**ALTERATION TO A HISTORIC PROPERTY STAFF REPORT**

Site / District(s)      9 Westwood Road, Charles Lamb House, Westwood Road LHD  
Case:                      HPC 12.129

Staff Recommendation: Recommend approval of a Certificate of Appropriateness with conditions  
Date of Public Hearing: 12/18/12

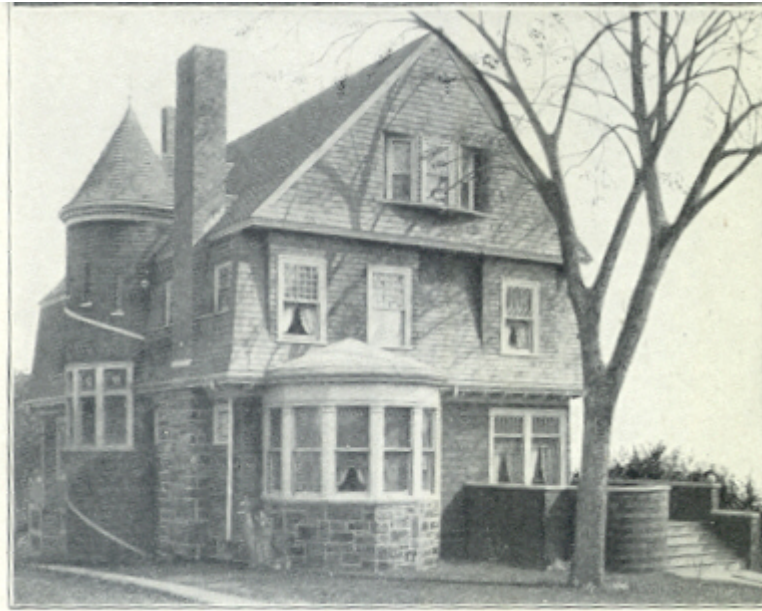
The windows are not described in Form B, however, the historic photo shows the original building as it looked in 1898. The proposed window is not visible in the photo and is located in the servants' portion of the building where simpler, less elaborate windows would have been the norm.

The Applicant would like to replace the windows with modern tight windows with no muntins or spacers. This is not based upon the physical evidence.

The proposed window replacement does not match the existing in design and is double glazed which, even with no Lo-E coating, there is a certain amount of distortion due to the double-glazing and changes in atmospheric pressure.. The viewing distance is such that other physical qualities would not be discernable.

The rear of the house is visible from Cambria Street. See photo.

- + Staff determines that the alteration for which an application for a Historic Certificate has been filed is appropriate for and compatible with the preservation and protection of the 9 Westwood Road, Charles Lamb House, Westwood Road Local Historic District; therefore **Staff recommends that the Historic Preservation Commission grant Sylvia and Arthur Shurcliff a Certificate of Appropriateness, with the condition that the windows have no Lo-E coating, a muntin and a spacer to match the existing historic window** because due to the distance from the street, it would not be “incongruous to the historic aspects or the architectural characteristics of the surroundings and of the historic district;” **and the windows be retained in storage for reinstallation at a later date, should a subsequent owner wish to do the needed repairs.**
